NORTHERN STATES POWER COMPANY  
MONTICELLO NUCLEAR GENERATING PLANT

REQUEST FOR AMENDMENT TO  
OPERATING LICENSE NO. DPR-22  
-----

(License Amendment Request Dated July 29, 1977)

PROPOSED CHANGES TO TECHNICAL SPECIFICATIONS  
APPENDIX A OF PROVISIONAL OPERATING  
LICENSE NO. DPR-22

Figure 1 Scram Reactivity and Control Rod Drive Specifications,  
Monticello Cycle 6

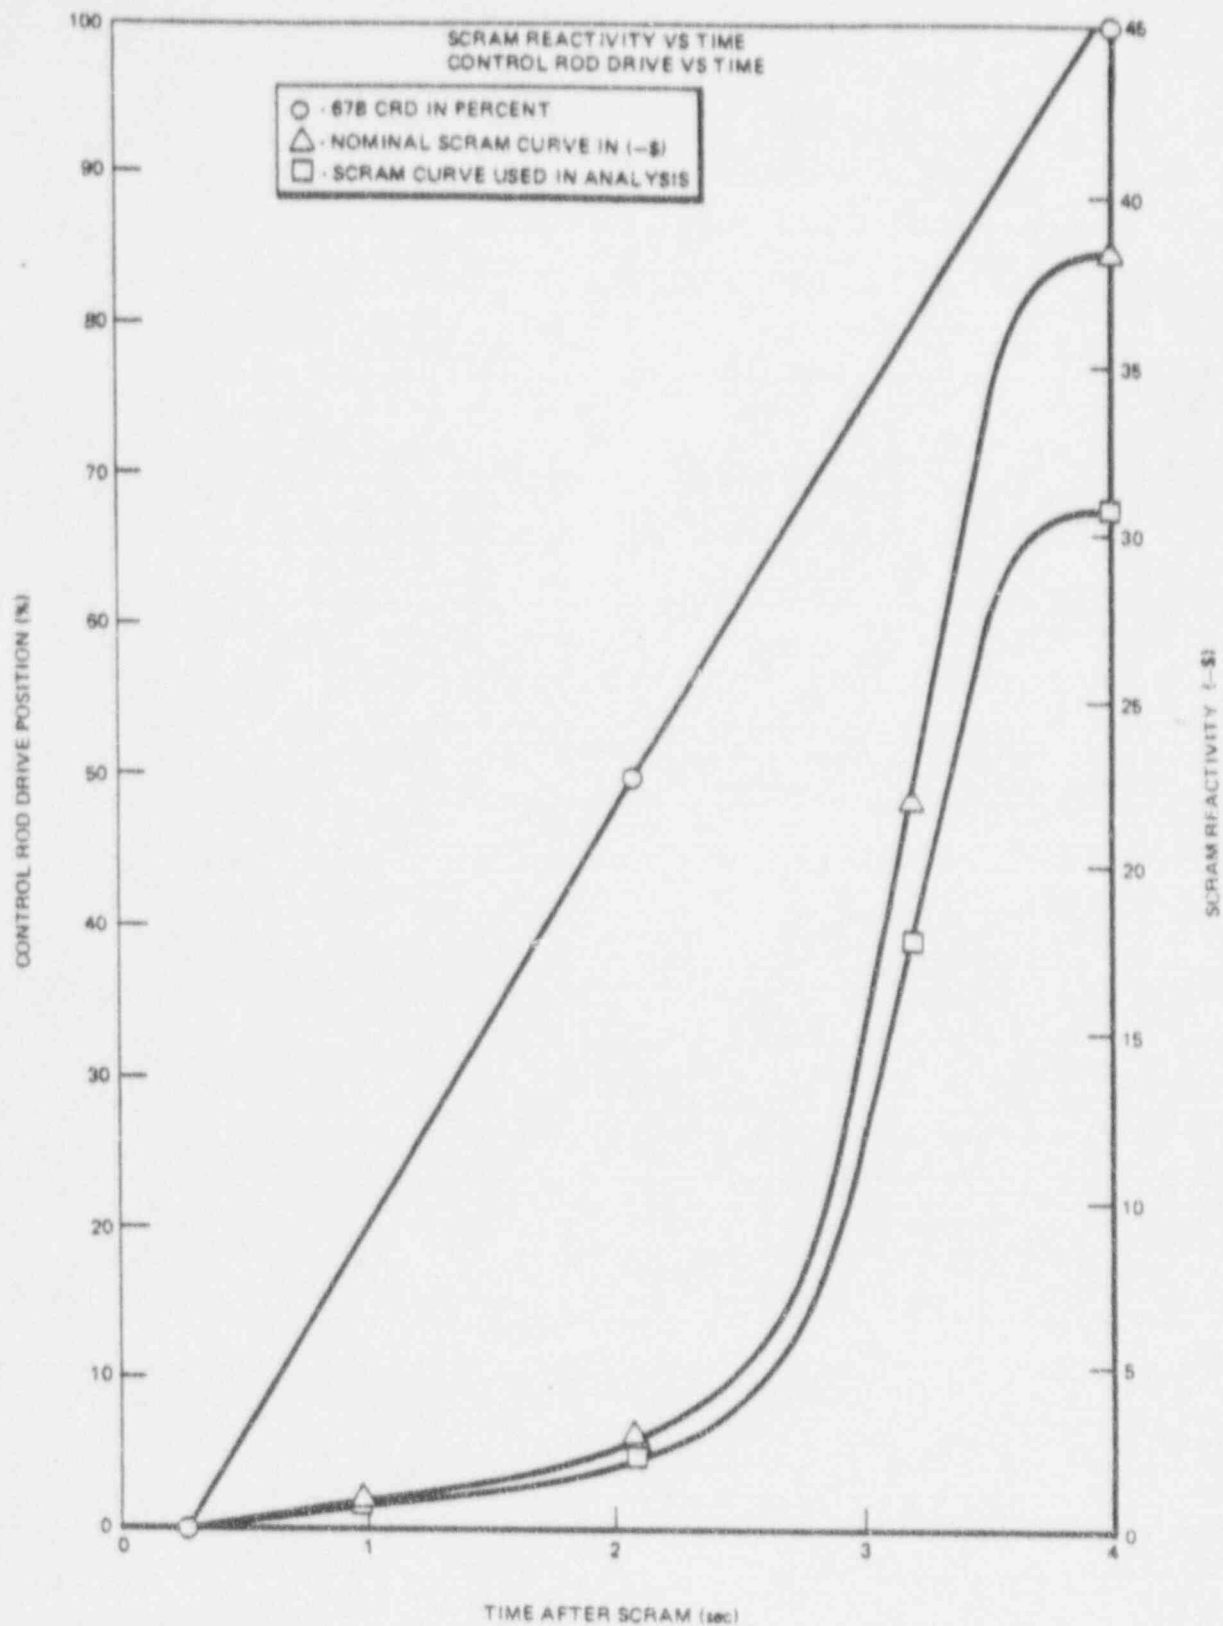
The MCPR operating limit is derived by adding to the MCPR safety limit the maximum delta CPR of the limiting abnormal operational transient. The reactor transients and the thermal hydraulic responses were analyzed as described in the topical report, "GE/BWR Generic Reload Licensing Application for 8x8 Fuel, Revision 1, Supplement 4, April 1976, NEDO-20360". It was found that at the end of the next cycle the turbine trip without bypass event and the generator load rejection without bypass event are equally limiting, having a delta CPR of 0.40 for 8x8 fuel. (All 7x7 fuel will be removed from the core during the next refueling outage.) The MCPR safety limit of 1.06 is not changed, placing the new MCPR operating limit at 1.46. The input and output for the limiting transient calculations are presented in the attached Tables 1, 2 and 3 and Figures 1, 2 and 3.

On Page 189D, TS 3.11.C and on Page 189F, first paragraph of Bases 3.11.C, change the operating MCPR limits from "1.38" to "1.46" and from "1.29" to "1.37" for 8x8 and 7x7 fuel respectively.

FIGURE 3 MONTICELLO  
TURBINE TRIP WITHOUT BYPASS, TRIP SCRAM

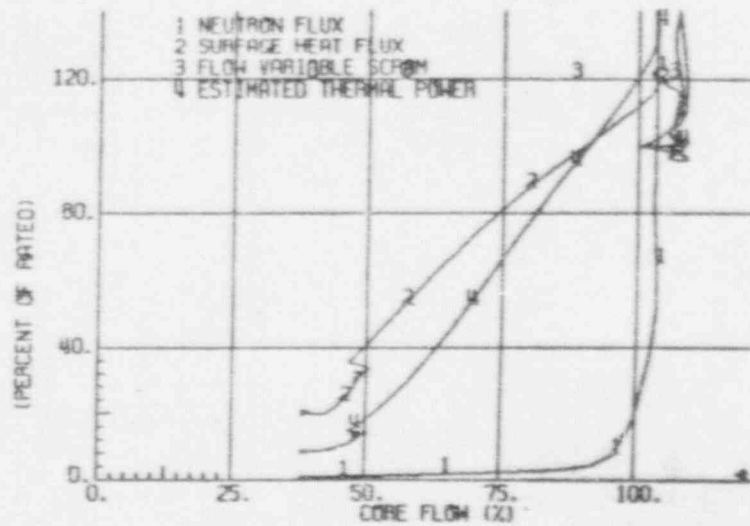
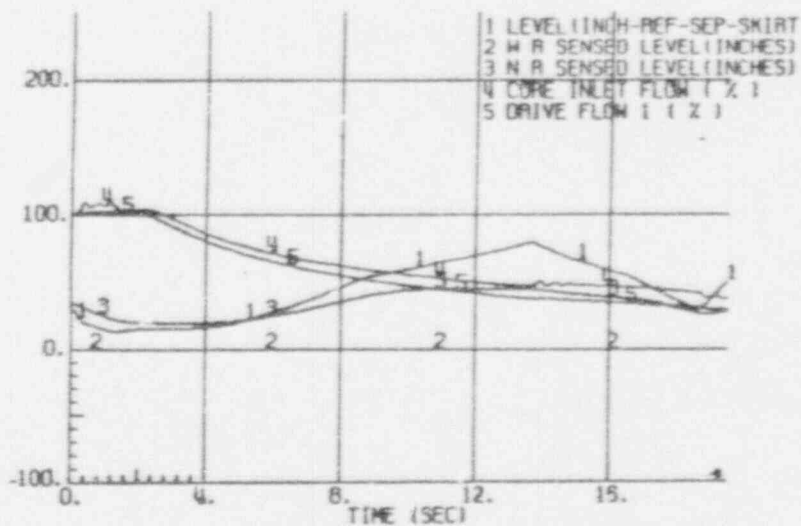
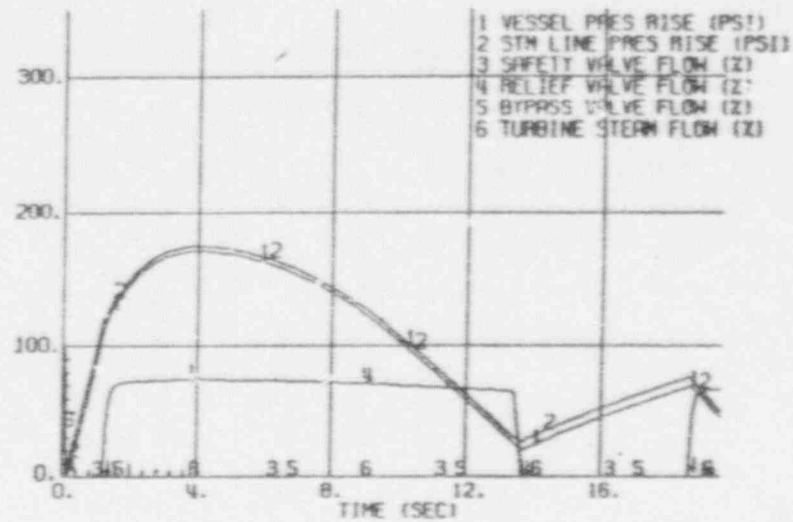
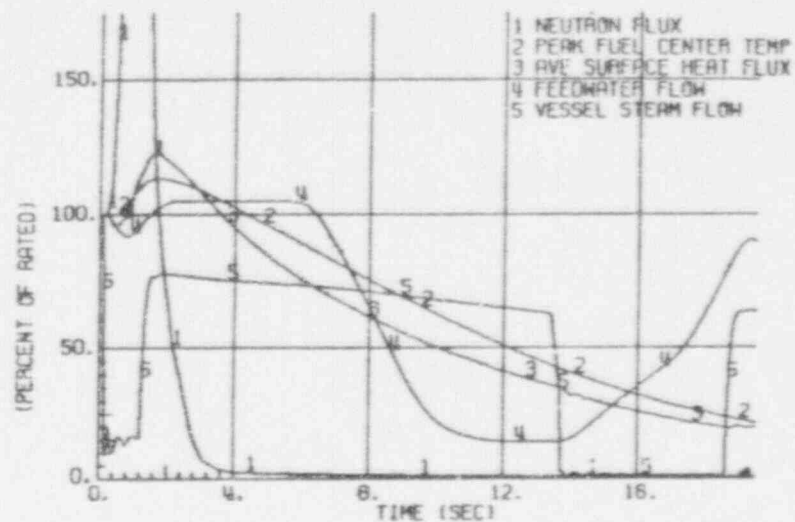
An analysis for conditions expected at the end of the next cycle was recently done using the same model as in the past except that GETAB replaced the Henschel-Levy correlation. The results of a turbine trip without bypass showed a delta CPR for the pump trip case 0.08 smaller than the case without the trip. In evaluating this unexpected situation, it was discovered that in the past the pump trip was modeled to occur too rapidly. The appropriate corrections, referenced to measured plant data, were incorporated into the model. The modified transient model was used for analysis of the next cycle. An adjustment of 0.08 to the MCPR operating limit is bounding for the duration of the present cycle. A re-analysis of the transient shows that the recirculation pump trip occurs too late to have any effect in determining thermal limits. Turbine and generator trips will continue to be modeled to include the pump trip to best represent the existing equipment.
